FIELD CHANGE

TRANSMITTING RADIO, SET

AN/FRT-39B, C, D, E, F, G, H

ELECTRONICS FIELD CHANGE BULLETIN	AN/FRT-39
BUREAU OF SHIPS, NAVY DEPARTMENT	AN/FRT-40
WASHINGTON, D. C.	AN/FRT-62

Figure 4.

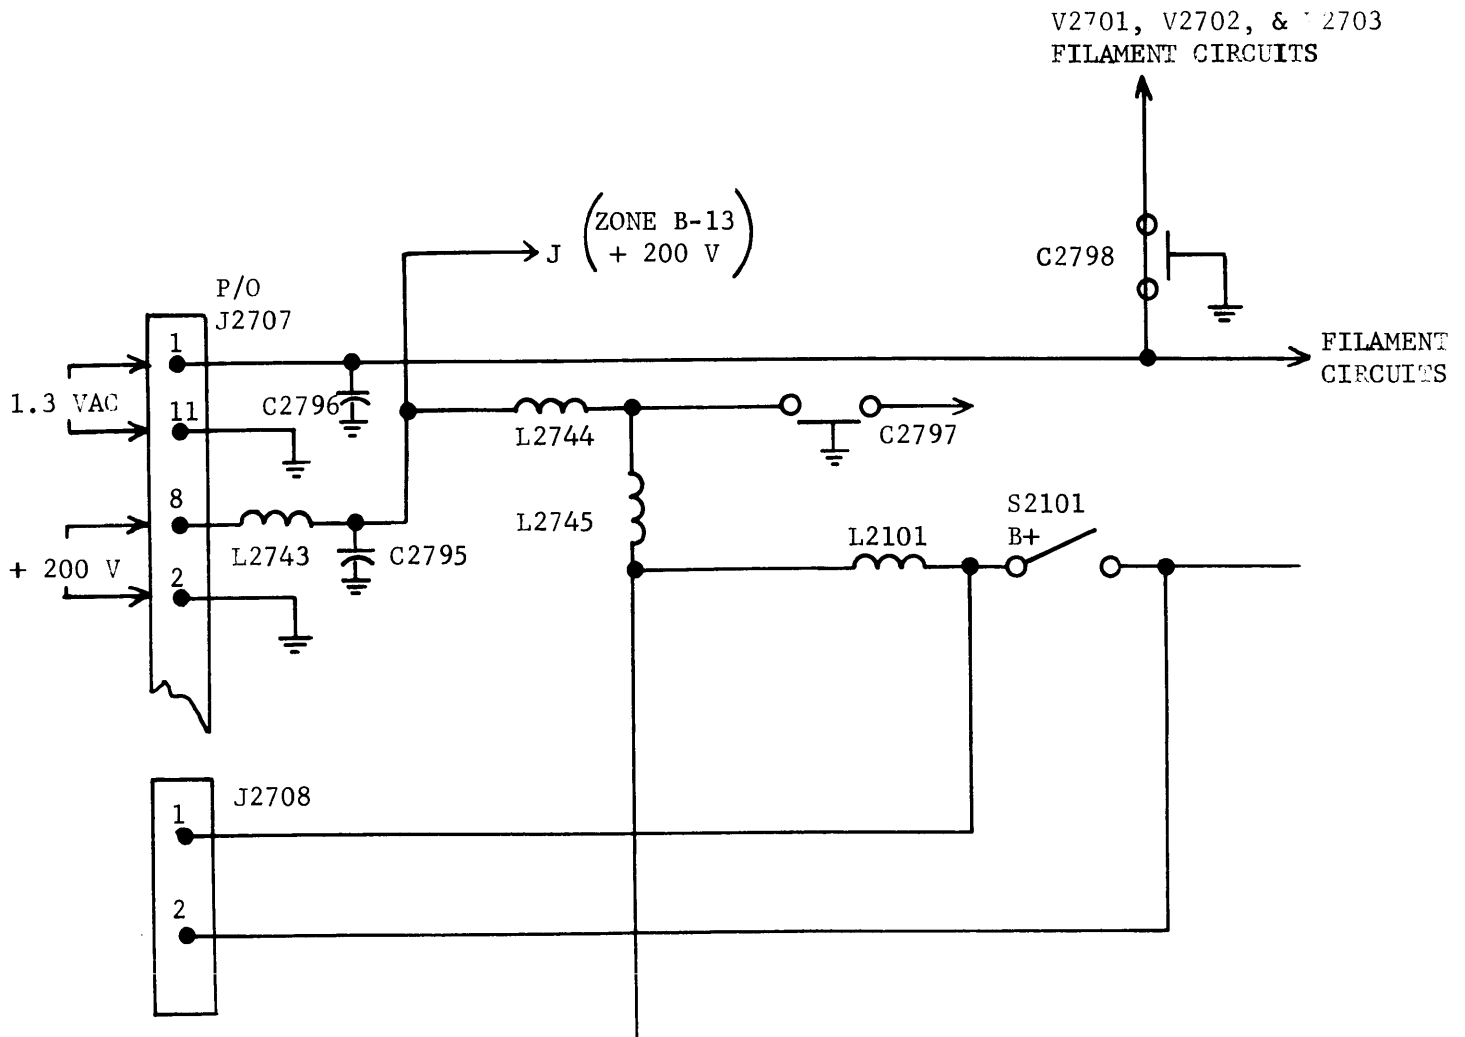
(a) Figures III(A)-4-5b, III(A)-4-6b, and III(A)-8-1b should be changed in accordance with the information provided in figure 4.
